<b>Table A-2a Methodology/Process Changes in ASME Code Case N-660 for WCGS Categorization</b>			
<b>N-660 Section</b>	<b>Endorsed Revision 0</b>	<b>WCGS IDP Version</b>	<b>Basis for Change</b>
-1200(a)	“... failure potential is conservatively assumed to be 1.0 in determining a consequence category in Appendix I.”	“...failure potential is conservatively assumed to be 1.0 in performing the initial consequence evaluation per I-3.1 in Appendix I.”	To be clear that the failure potential is conservatively assumed to be 1.0 in I-3.1, Consequence Evaluation. This allows the expert panel to assume other than 1.0 for the failure potential when considering the other relevant information in I-3.2 for piping segments determined to be Medium, Low, or None consequence category in I-3.1.
-1200(b)	“Class 1 items that are part of the reactor coolant pressure boundary...”	“Items optionally classified to Class 1 and Class 1 items...”	Although this section was modified for the WCGS IDP Version there were no Class 1 items in the two systems evaluated at Wolf Creek. Therefore, this provision was not applied at Wolf Creek. Nonetheless, it was decided that for all future applications at Wolf Creek all Clas

Figure I-1  
Risk-Informed Safety Classification Process

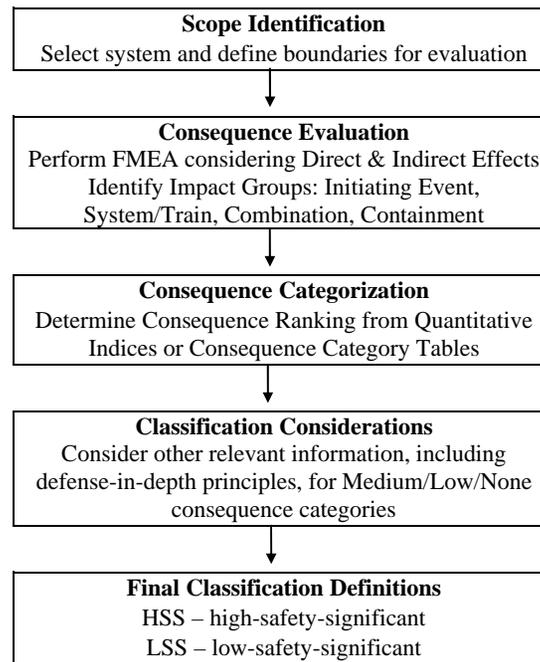
I-1.0	N/A	Added figure <sup>1</sup> illustrating the modified RISC methodology process, including scope identification, consequence evaluation, consequence categorization, classification considerations, and final classification definitions.	Figure added to provide high level overview of RISC methodology process. New process calls for all segments to be included in the consequence evaluation to determine high, medium, low or none consequence category. Then only the non-high category segments would be considered in the classification considerations of I-3.2.2(b) – previously I-3.1.3.

Note 1 – Figure I-1, Risk-Informed Safety Classification Process
